**ADDENDUM NO. 3**

IRONDALE FIRE STATION No. 3

THIS ADDENDUM FORMS A PART OF THE CONTRACT DOCUMENTS. THE FOLLOWING CONDITIONS TAKE PRECEDENCE OVER ANY CONFLICTING CONDITIONS IN THE DRAWINGS AND SPECIFICATIONS. THE DRAWINGS AND SPECIFICATIONS ARE HEREBY AMENDED IN THE FOLLOWING PARTICULARS.

SHEET NUMBER  
**A2.30**

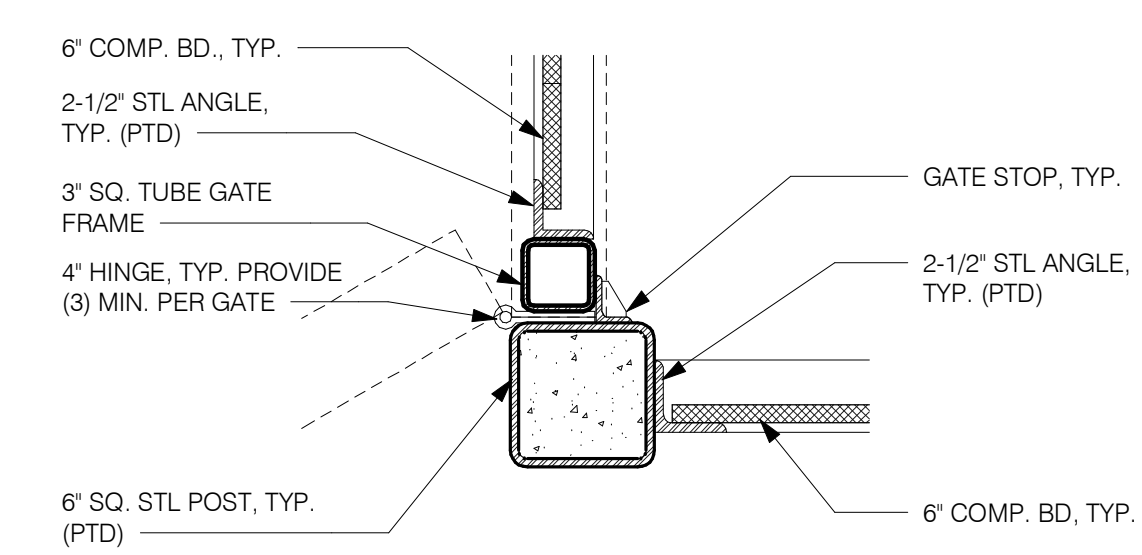
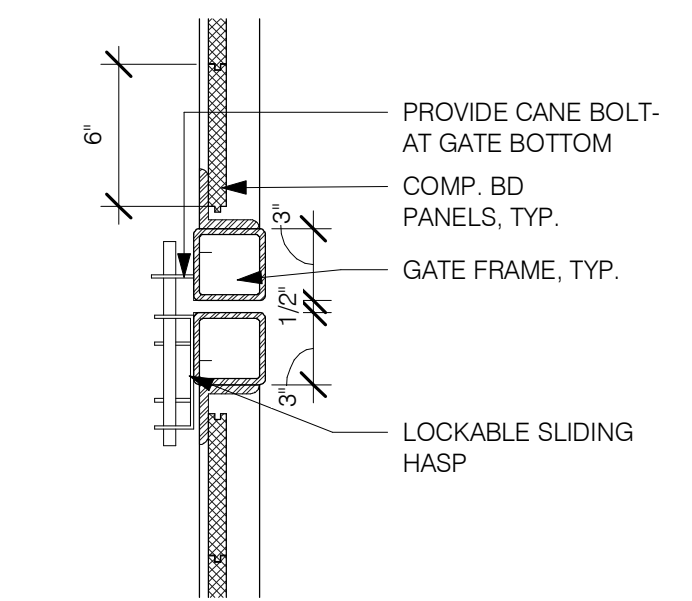
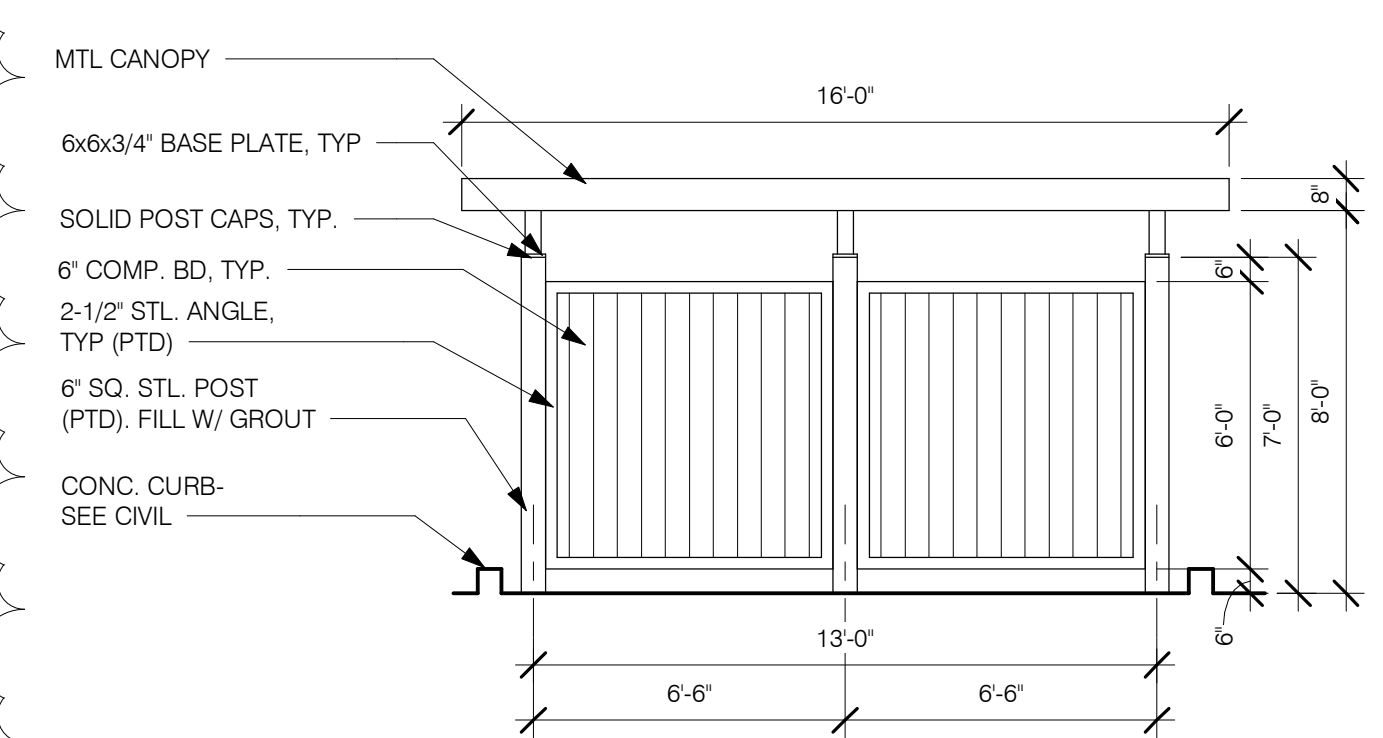
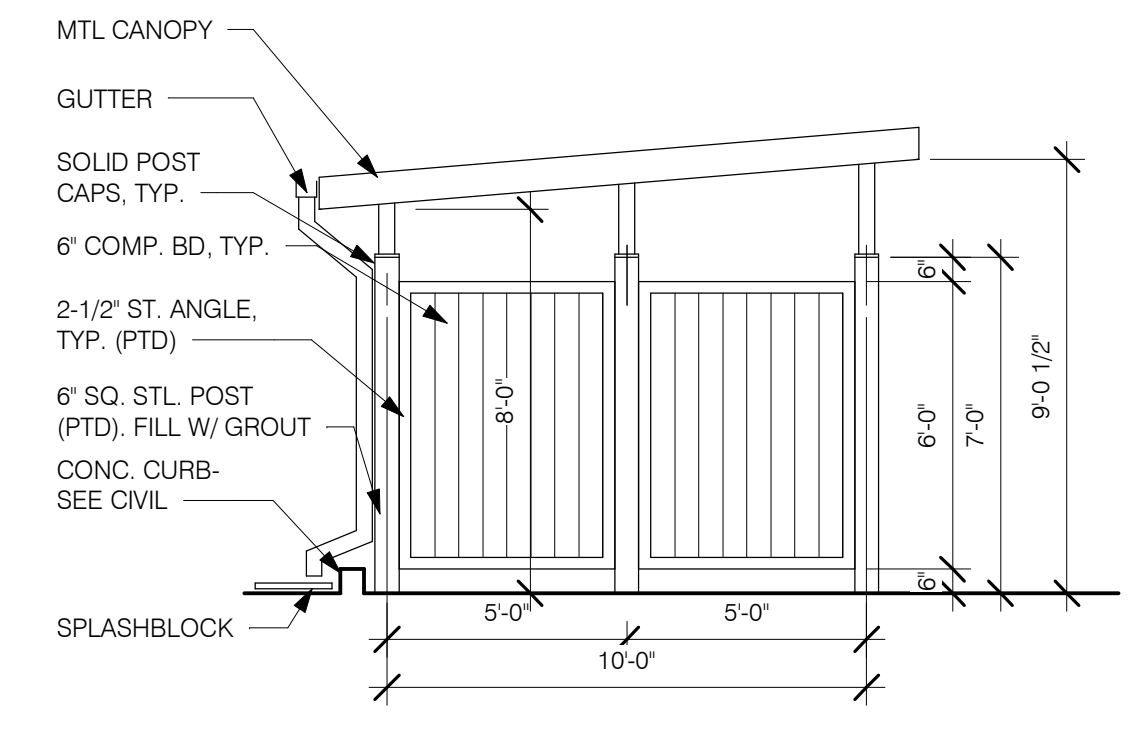
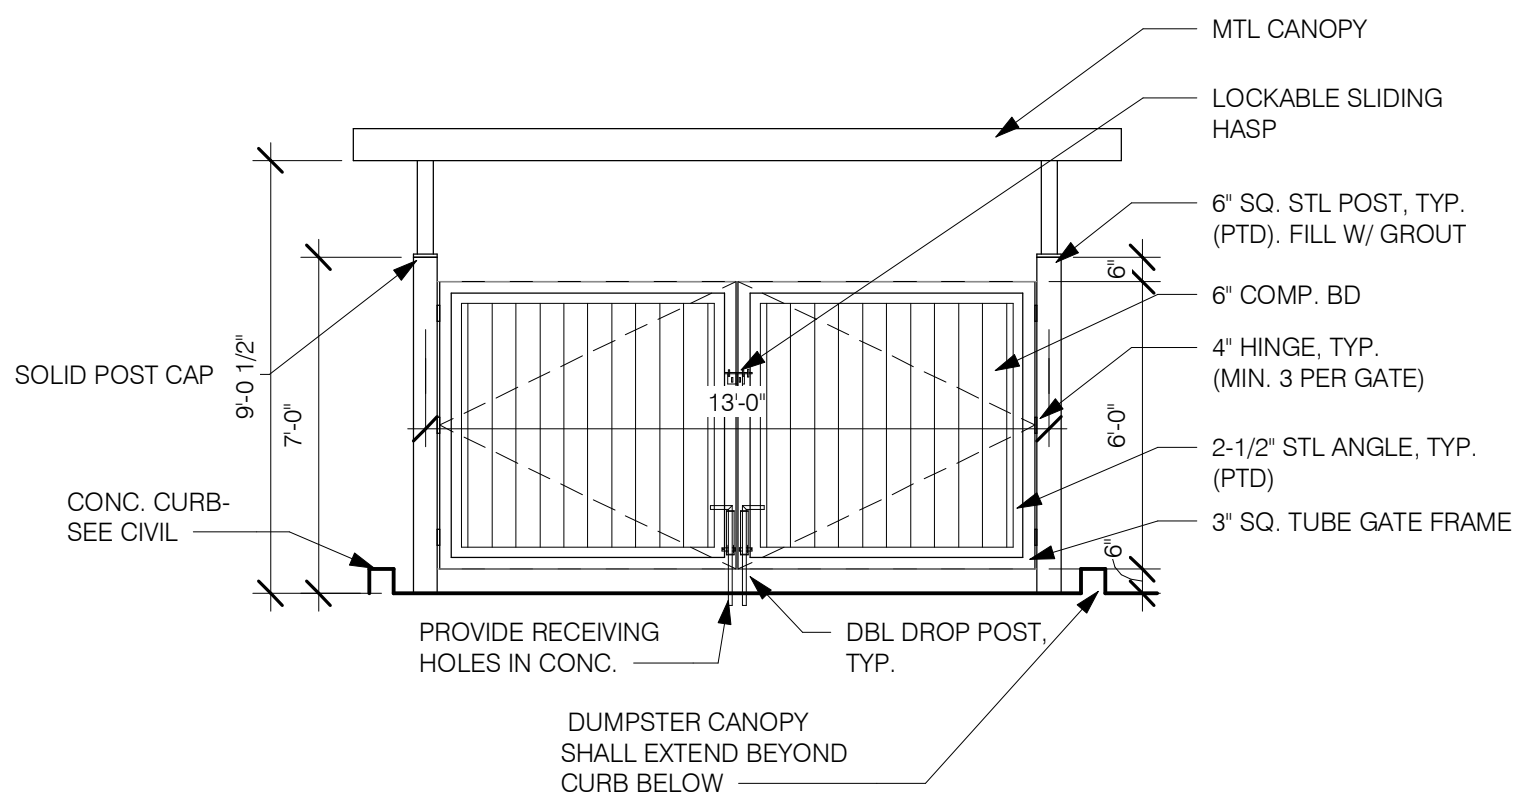
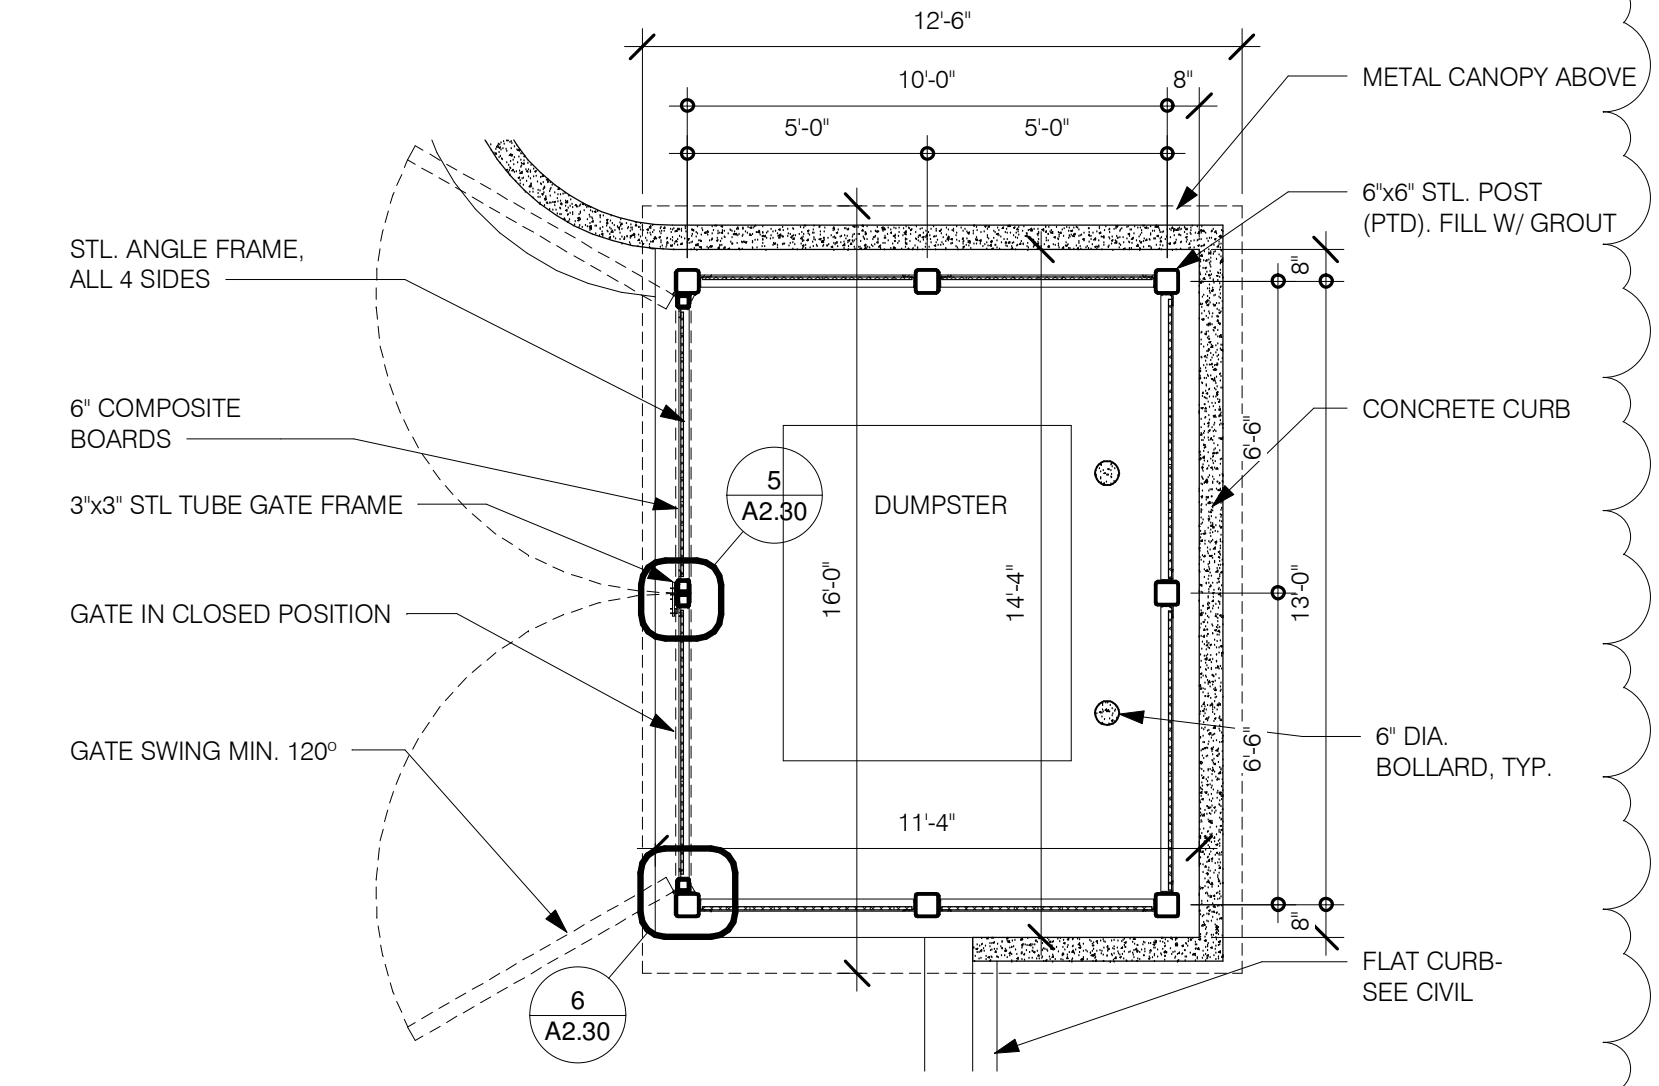
11. A2.30 - Dumpster Enclosure Plan & Details: Added metal canopy over the dumpster
12. A2.21 Enlarged Plan Block B (Dorm): Change wall type of wall between Watch 105 and Office 107 to S6AA (6" thick stud with drywall).
